TRANS/WP.29/2003/11
12 December 2002

PROPOSAL FOR DRAFT SUPPLEMENT 3 TO REGULATION No. 98

(Headlamps with gas-discharge light sources)

Transmitted by the Working Party on Lighting and Light-Signalling (GRE)

"Annex 4 - Appendix 1

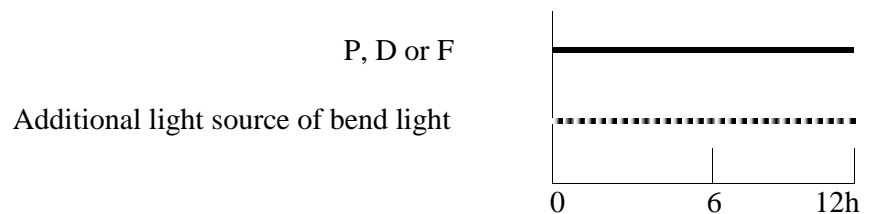
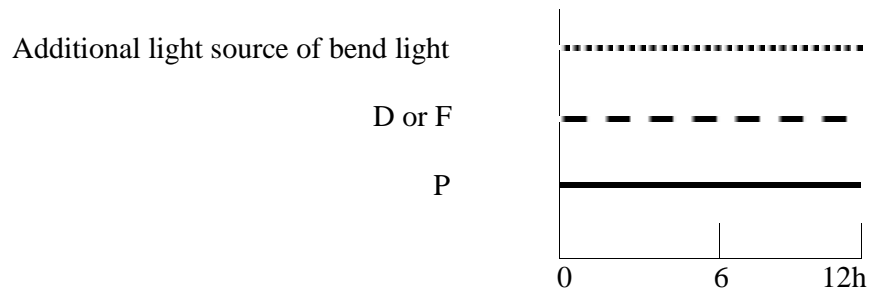
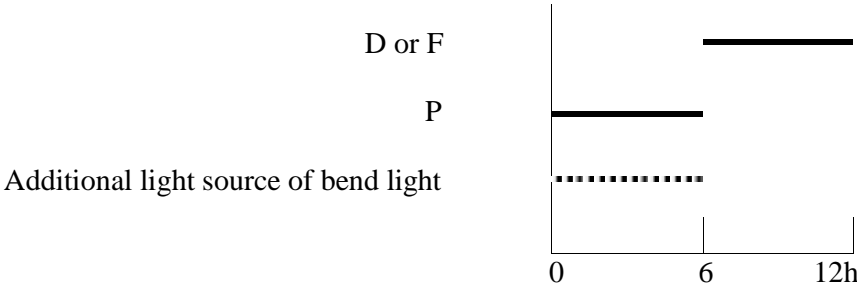
Annex 4, paragraph 1.1.1.1., add a new subparagraph (d) to read:

- "(d) In the case of a passing beam designed to provide bend lighting with the addition of a light source, this light source shall be switched on for 1 minute, and switched off for 9 minutes during the activation of the passing beam only (see annex 4 - appendix 1)."

Insert new Annex 4 - appendix 1, to read:
